CONSTRUCTION SUMMARY

Kingsmen (Thames) Inc. / Havelock Corners (Kingsmen)

Lot/Unit: 29 Phase/Building: 4A Model/Floor Plan: Arthur (4205) Elev C 4 Bed - 4+1 Bath

Schedule B-1 1 of 3 Sketch #/

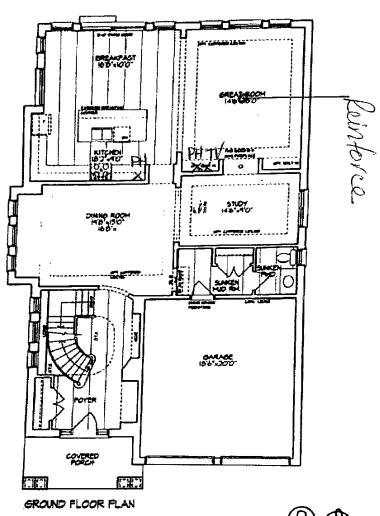
Inv. 4544	2 - To reinforce the following std. ceiling lights; Great room and O.T.B on the uper hallway	
	See sketch # 1 & #2	
Line 57970	Note:	
12Feb20 / 20Mar20		
Inv. 4544	1 - To supply & install the std. T.V. rough in's one in the Great room and the other one in the	
	master bedroomsee sketch	
Line 57775	Note:	
12Feb20 / 20Mar20		
Inv. 4544	1 - To supply & install the std. Phone rough in's one in the Kitchen, one in the Great room	
	and the other one in the master bedroomsee sketch	
Line 57776	Note:	
12Feb20 / 20Mar20
